Access Compliance Report

Public Rights-of-Way

Intersection ID: 28662	Main Street: MEADOWMONT_DR	Cross Street: MEADOWMONT_VIEW_DR	Location: NE
ADA ID: EF4A2EE0873E	Ramp Type: BlendTrans1	Initial Pass/Fail: Pass	Overall Compliance: No
			Severity Score: 7.5

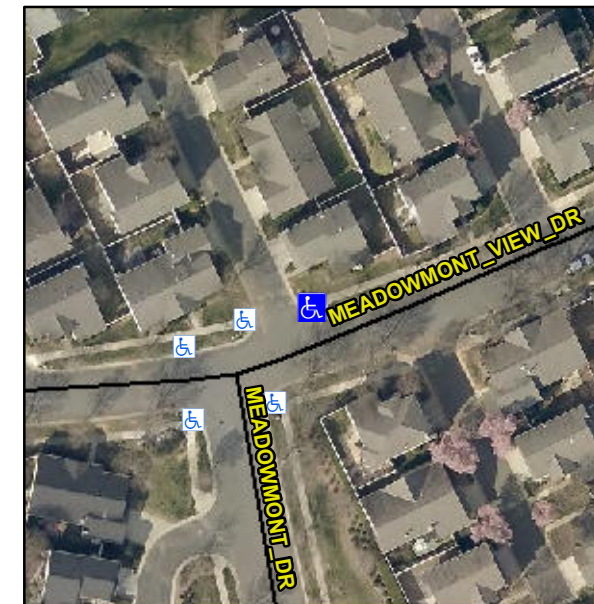
Compliance	Description	Data	Compliance	Description	Data
N/A	Ramp Length (in)	24.0	Yes	BlendTrans Slope (%)	2.3
Yes	Ramp Width (in)	48.0	Yes	BlendTrans XSlope (%)	1.3
N/A	Flare Type LT	Sloped	N/A	Flare Type RT	Sloped
N/A	Flare Slope LT (%)	2.1	N/A	Flare Slope RT (%)	2.0
N/A	Flare Traversable LT?	No	N/A	Flare Traversable RT?	No
No	Landing Length (in)	32.0	Yes	DWS Provided?	Yes
Yes	Landing Width (in)	48.0	Yes	DWS Contrast?	Yes
No	Landing Slope (%)	2.3	Yes	DWS Length (in)	24.0
Yes	Landing X Slope (%)	0.7	Yes	DWS Full Width?	Yes
N/A	Landing Curb? (Y/N)	No	Yes	DWS Offset (in)	2.0
N/A	Shared Landing?	No			
Yes	Gutter Ponding?	No	Yes	Gutter Slope (%)	2.1
No	Gutter Lip Ht (in)	0.3	Yes	Gutter X Slope (%)	0.4
N/A	Painted X Walk1?	No	N/A	Painted X Walk2?	N/A
	X Walk 1 Direction	To W		X Walk 2 Direction	N/A
	X Walk 1 Width (in)	N/A		X Walk 2 Width (in)	N/A
	X Walk 1 Slope (%)	1.4		X Walk 2 Slope (%)	N/A
	X Walk 1 X Slope (%)	0.2		X Walk 2 X Slope (%)	N/A

N/A	Ramp inside XWalk1?	N/A	N/A	Ramp inside XWalk2?	N/A
	Road Slope (%)	0.2		Clear Space?	Yes
	Road X Slope (%)	1.4	N/A	Clear Space to XWalk (in)	N/A
Yes	Any Obstructions?	No	Yes	Storm Grate/Utility Hazard?	No
	Obstruction Type			Storm Grate/Utility Type	
		N/A			N/A
			Yes	Surface Condition? (G/P)	Good
			N/A	Curb Slope (%)	N/A

Remove & Replace Landing. Grind Gutter Lip.
